**Re: Implementation of the Alternative Energy Portfolio Standards Act of 2004
Standards for the Participation of Demand Side Management Resources –
Technical Reference Manual Update
Docket No. M-20051865**

**COMMENTS OF
DUQUESNE LIGHT COMPANY**

**Figure 4.13
Indoor CFL Load Shapes by Day Type**

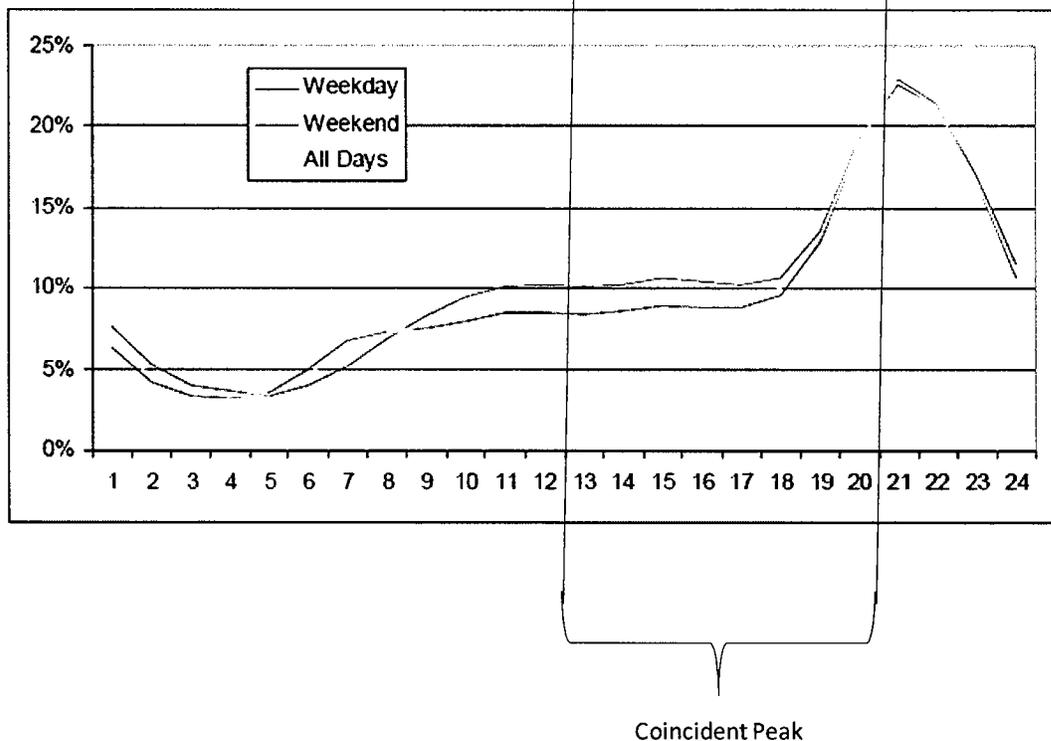
Coincidence factor (“CF”) is the ratio of the “installed unit’s connected load to its demand at time of system peak.” Draft TRM at 15. Duquesne believes that the 5% CF adopted in Draft TRM Table 4-3 (on page 31 of the Draft TRM) is too low. As can be seen in the chart provided below, residential CFLs are used throughout the system coincident peak period as defined in

TRM Table 1-1. The 3 average hours of use per day for residential CFLs also set forth in Table 4-3 are likely to occur between noon to 8 p.m., which coincides with the period of system peak. Accordingly, Duquesne finds the 5% extraordinarily low in view of this demonstrated use pattern. A more appropriate treatment would be to consider the 3 hours to be within the 8 hours and afford the measure to be 37.5% (3/8). Please see Table 1-1 from the Draft TRM and Figure 4-13 from the KEMA CFL Metering Study Final Report below for reference.

Based on this reference, residential CFLs operate across all 8 hours of the system coincident peak demand period. Accordingly, the stated daily 3 operating hours should be treated as occurring during the peak period 3 out of 8 hours or 37.5%.
